FLOOR END ASSEMBLIES UPGRADE:
1733 SERIES TO 2620 SERIES

GL1049

BIG ACE PIPE

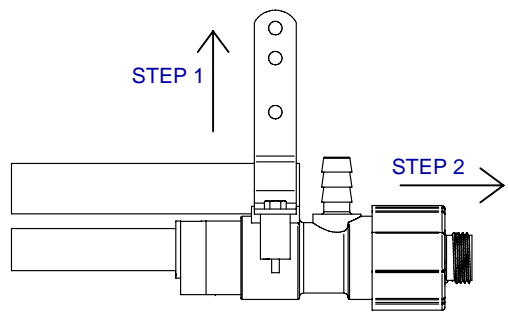
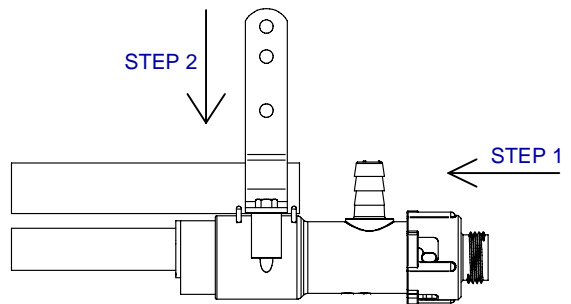
REMOVE 1733 SERIES FLOOR END ASSEMBLY

CUT OFF 3/4" / 1.9 cm OF BIG ACE PIPE (REMOVE BURR BEFORE INSTALLING THE NEW VERSION)

ADD NEW 2620 SERIES END ASSEMBLY AS SHOWN

ACE PIPE

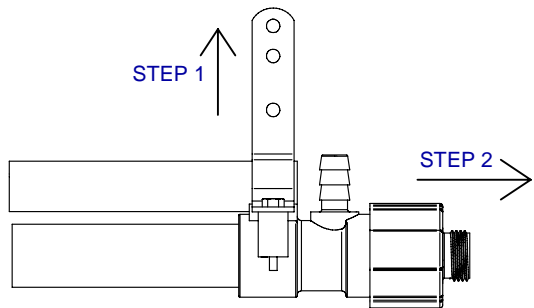
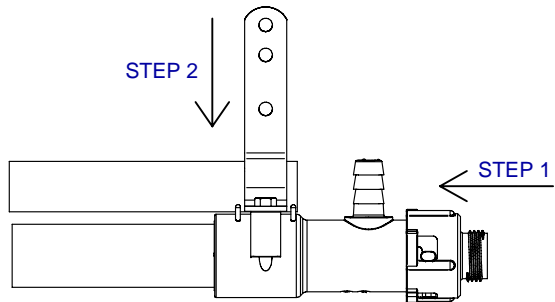
REMOVE 1733B SERIES FLOOR END ASSEMBLY

CUT OFF 13/16" / 2.1 cm OF ACE PIPE (REMOVE BURR BEFORE INSTALLING THE NEW VERSION)

ADD NEW 2620 SERIES END ASSEMBLY AS SHOWN
